Our Ref: 142/L02

**RE: ELF FARM SUPPLIES
MUSHROOM SUBSTRATE PLANT, MULGRAVE
RESPONSE TO SUBMISSIONS: MP08_0255-MOD 4**

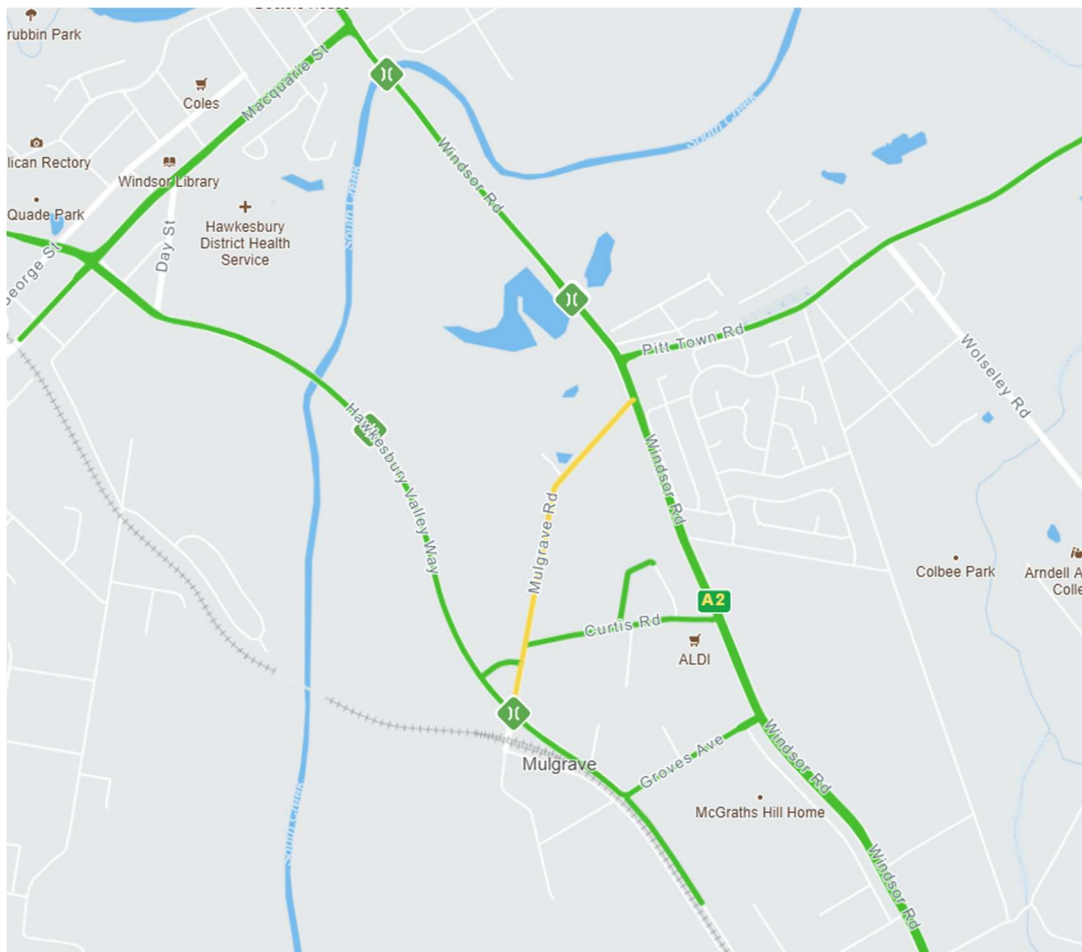
- i) *Provide additional traffic mitigation measures to minimise vehicle movements associated with bulk earthworks causing further deterioration of the level of service at the existing Hawkesbury Valley Way/ Mulgrave Road intersection.*

This matter was referred to the traffic consultant, *pdc consultants*, who supplied the traffic impact assessment report included in the application. The consultant advised that the report includes a recommendation that an operational traffic management plan be prepared to among other things detail alternate routes to avoid peak hour congestion at Hawkesbury Valley Way / Mulgrave Road.

Responding to the specific issue the consultant advised the alternate routes would be the B-Double network to Windsor Road (extract below), including use of Mulgrave Road and Curtis Road
